**ADDENDUM NO. 2**

TOWN OF WINDHAM INTERMODAL TRANSPORTATION CENTER

DATE OF ISSUANCE: June 17, 2019 WALKER PROJECT #: 16-2958.00  
OWNER: Town of Windham

1. Sketch SK-1
2. Pre-Bid Attendance Sign-In Sheet

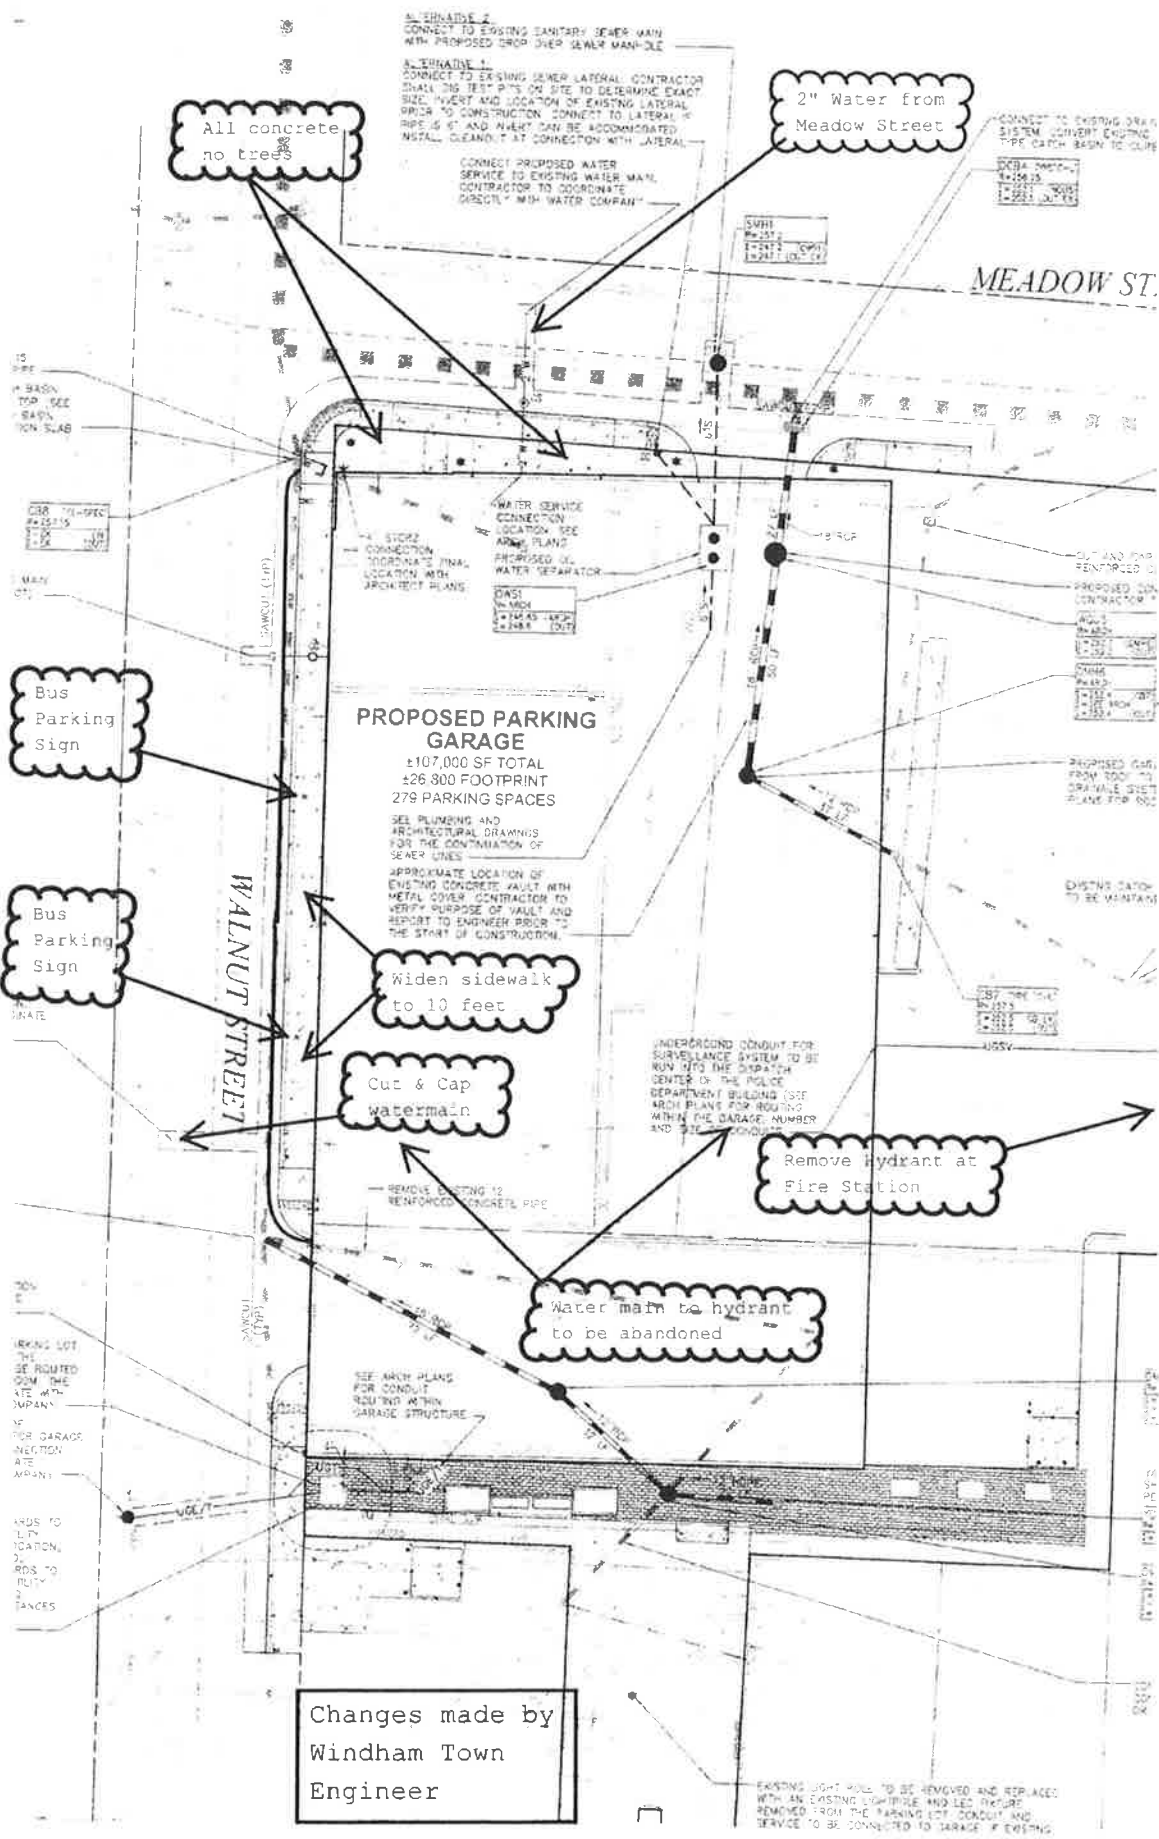
5. Clarification – Refer to the attached sketch SK-1 for clarifications on the utility scope. This information shall be used in conjunction with the utility information provided on C-104.

All concrete  
no trees

2" Water from  
Meadow Street

Widen sidewalk  
to 10 feet

Cut & Cap  
watermain

Remove hydrant at  
Fire Station

Water main to hydrant  
to be abandoned

Changes made by  
Windham Town  
Engineer

ALTERNATIVE 2  
CONNECT TO EXISTING SANITARY SEWER MAIN  
WITH PROPOSED DROP OVER SEWER MANHOLE

ALTERNATIVE 1  
CONNECT TO EXISTING SEWER LATERAL. CONTRACTOR  
SHALL DO TEST DIG ON SITE TO DETERMINE EXACT  
SIZE, INVERT AND LOCATION OF EXISTING LATERAL.  
PRIOR TO CONSTRUCTION, CONNECT TO LATERAL.  
PIPE 4" AND ABOVE CAN BE ACCOMMODATED.  
INSTALL CLEANOUT AT CONNECTION WITH LATERAL.

CONNECT PROPOSED WATER  
SERVICE TO EXISTING WATER MAIN.  
CONTRACTOR TO COORDINATE  
DEPOSIT WITH WATER COMPANY

CONNECT TO EXISTING DRAIN  
SYSTEM. CONVERT EXISTING  
TYPE CATCH BASIN TO CURB
